Fraying Headliner Cords

Topic number	LI77.30-P-070145
Version	1
Function group	77.30 Vario roof, soft top - complete
Date	08-15-2019
Validity	205 and 238 cabrios produced before June 2019
Reason for change	
Reason for block

Abb.4.jpg:

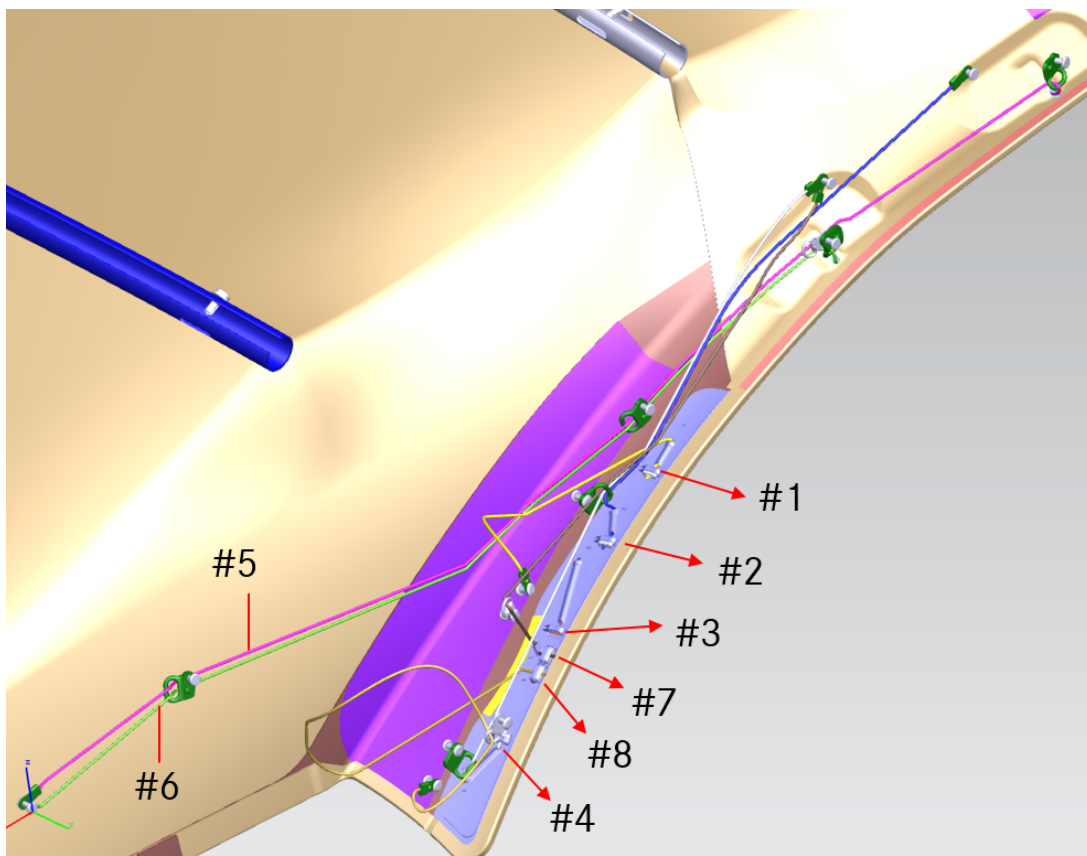
If damage is found on one of the cords no. 3, 4 or 7 of the soft top interior trim, replace all the cords nos.3, 4 and 7 on the left and right as a preventive measure. See figure 4 for labelling of the cord.

Abb.9.jpg:

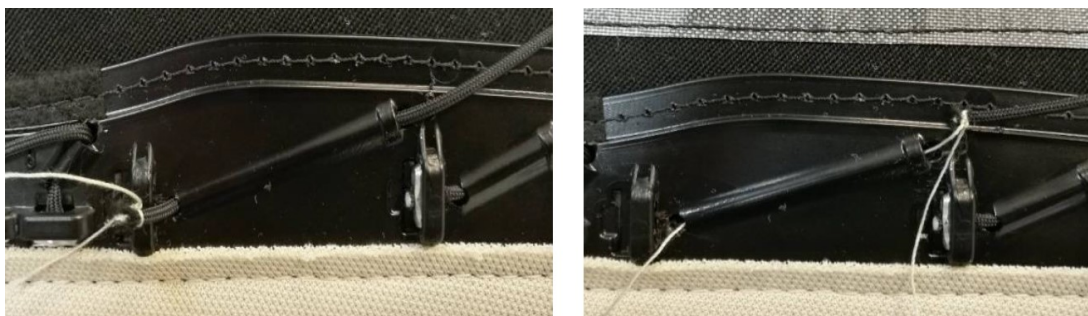
5.) After removing the clamping ring connection, attach a makeshift thread to the end of the defective cord in order to route the new cord:

Pull the damaged cord through the duct, leaving the thread inside the duct to facilitate installation. Detach the thread from the damaged cord.

See Fig. 9. - Attaching the makeshift thread.

Abb.20.JPG:

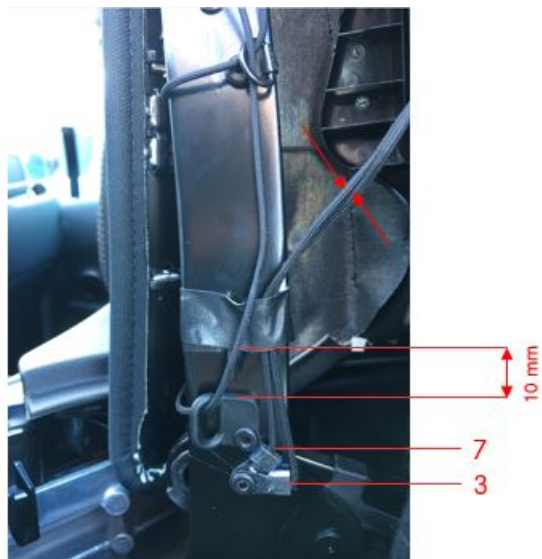
- Adhesive tape guide for the cords no. 3 and no. 7:

Make sure that cords 3 and 7 are routed behind the adhesive tape. As a reference dimension, the adhesive tape should be positioned approx. 10 mm from the eyelet.

See Fig. 20.

Abb.23.JPG:

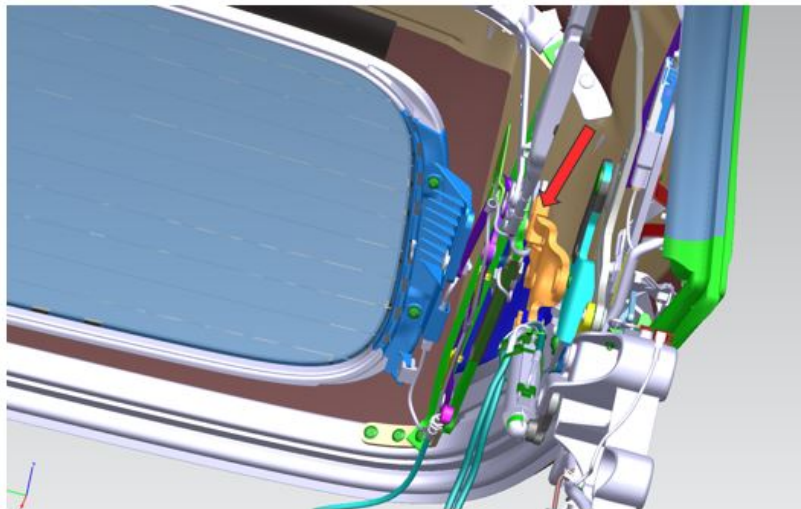
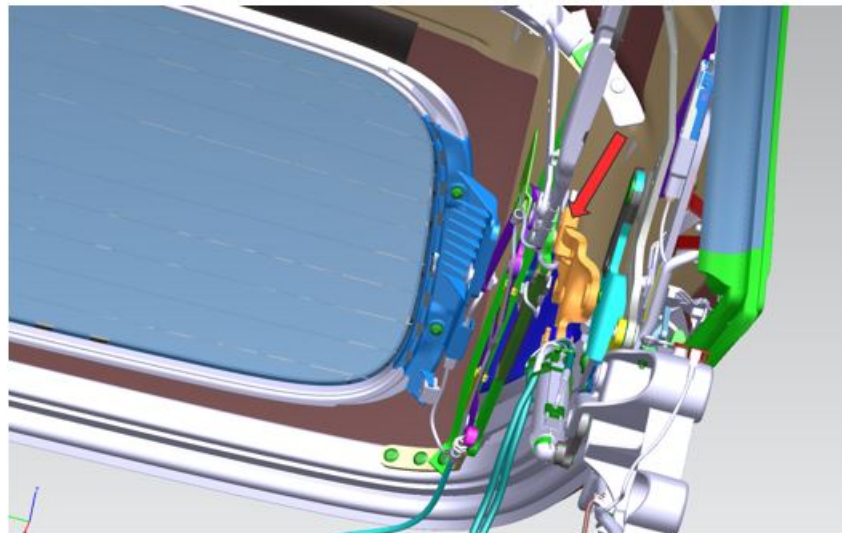
- Old/new bellcrank end stop:

The repair kit also includes new end stops. Replace both sides on left and right.

See Fig. 23. - Old

See Fig. 24. - New

Abb.25.JPG:

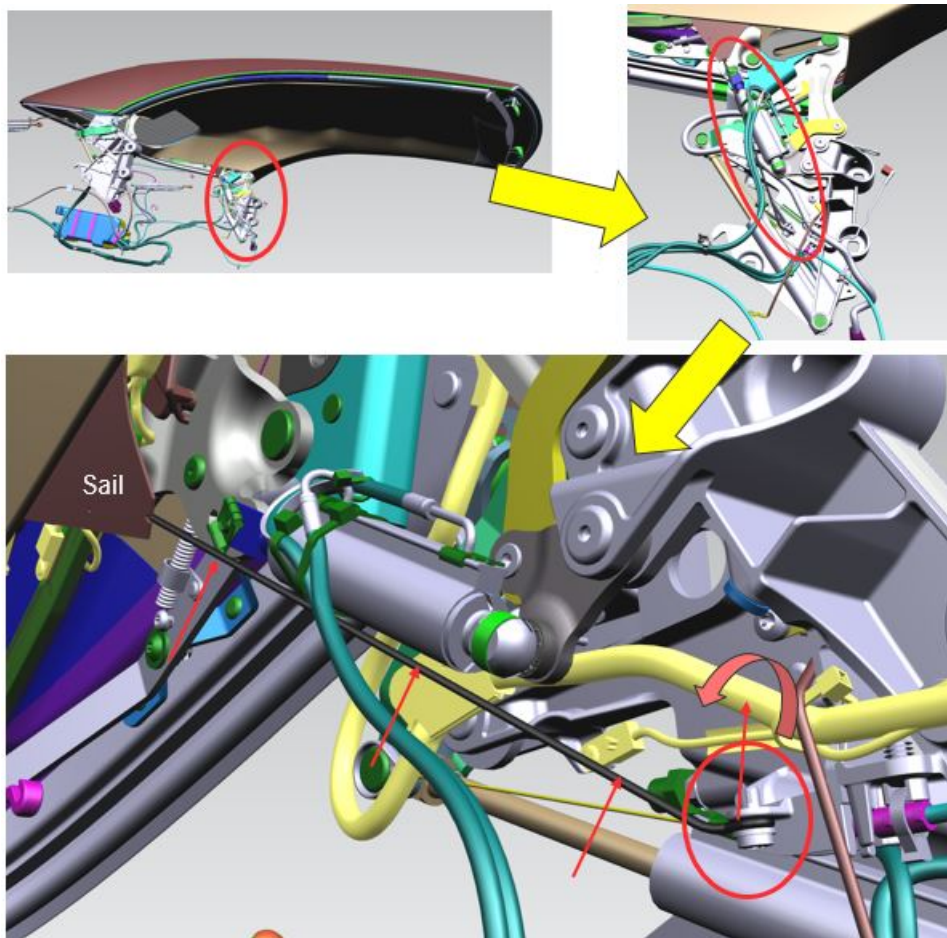
With the new soft top interior trim, the cord no. 3 has been discontinued and the design line improved in the area of the C-pillar. Only new parts are available as replacements.

In vehicles produced prior to the change, which require a new soft top interior trim in repair cases, the tensioning strap is fastened

to the wiring harness with a small cord strap.

See Fig. 25.
